Rezoning Transportation Analysis

Petition Number: 2025-123

Revision Log:

Date	Description
12-23-25	First Review (IW)
02-19-26	Second Review (KC)
07-23-26	Third Review (IW)
08-25-26	Fourth Review (IW) ZC

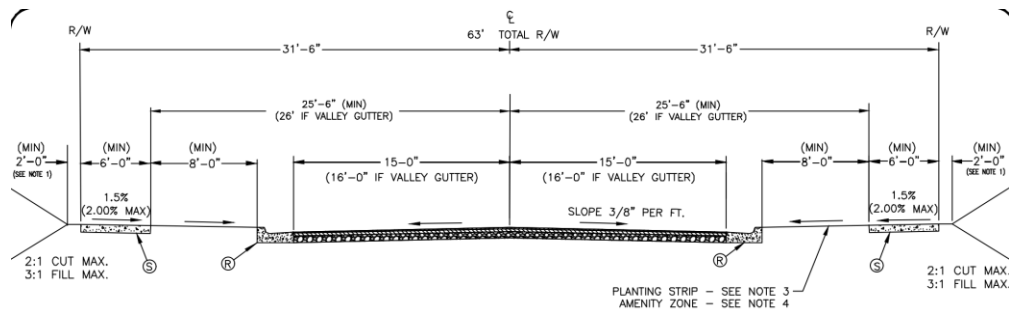
~~The petition's zoning falls within the low intensity development which based on the 2,242 daily trips will trigger Tier 3 (9 mitigation points) for multimodal assessment. The petitioner shall review and assess the publicly accessible pedestrian network within 1/4 mile walking distance of the site to identify multimodal infrastructure to meet the Tier 3 (9 mitigation points) for multimodal assessment.~~

~~Complete CTR summary table and include it on the revised plan. CTR table link (use Site Data Table — CTR Summary tab): <https://www.charlottenc.gov/files/sharedassets/city/v/2/growth-and-development/documents/dev-center-fees/resources/udo-site-data-tables-curb-ramps-and-ctr.xlsx>~~

~~TIS scope was approved on 02/13/2026.~~

~~TIS was approved on 5/26/2026.~~

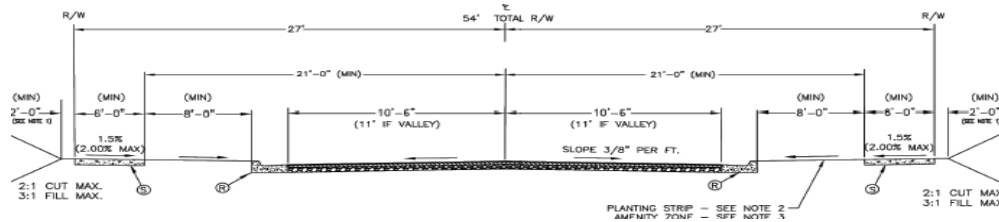
7. ~~**Outstanding comment 07/23/26:** Add a conditional note specifying “the Petitioner shall dedicate and convey in fee simple all rights of way to the City before the site’s first building certificate of occupancy is issued. CDOT requests rights of way set at 2’ behind back of sidewalk where feasible.”~~
~~**Clarifying Comment 07/23/26:** Remove Note D under transportation and add note exactly as stated above. The above statement includes all right of way that is required to be dedicated and conveyed.~~

~~Remove portion related to new dwelling single family detached in note “H”. The statement of “in fee simple ALL rights of way to the city...” covers everything including the single family detached homes. CDOT does not want any confusion when it comes to dedicating the right of way.~~
